CITY OF ALBUQUERQUE

**Re: O'Reilly Auto Parts
12700 Lomas Blvd NE
Request 60-Day Temporary C.O. – Accepted
Engineer's Stamp dated: 1/28/2016 (K22D019)
Certification dated: 9-8-16**

PROJECT:
NEW O'REILLY AUTO PARTS STORE
12700 LOMAS BLVD NE
ALBUQUERQUE, NM 87123
SITE GRADING PLAN

4 STANDARD DRAWING 2236 - DRAINAGE SIDEWALK CULVERT WITH STEEL PLATE TOP
SCALE: NOT TO SCALE

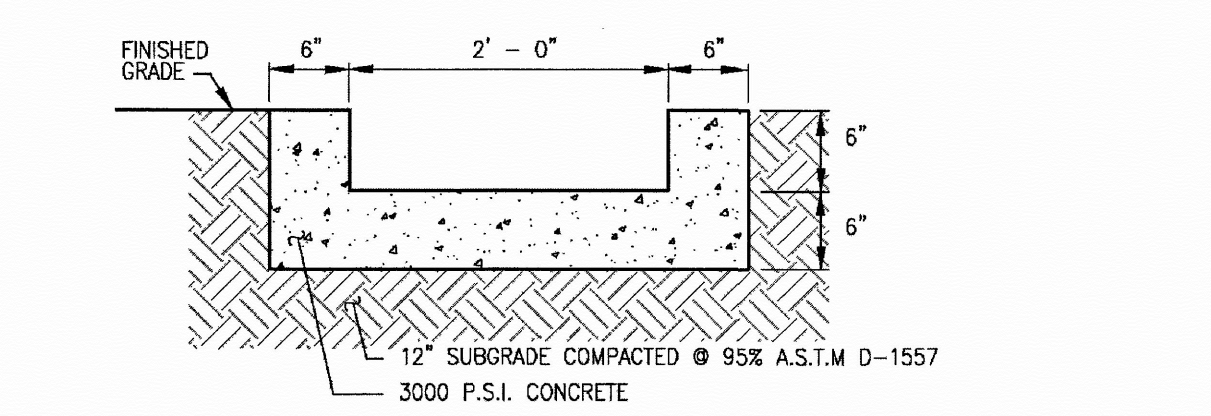
- The plate on the sidewalk culvert at the curb end is past the face. It needs to be shortened flush with the curb or preferably shorter as to not damage the tires of a parked vehicle.
- Two bolts are missing on the S/W culvert. At least four of the bolts need to be tack-welded.
- There is no expansion material on both sides of the culvert. It can be saw cut and filled with NP-1 sealant.
- It is recommended the ponding on the street at the new curb and gutter be investigated.
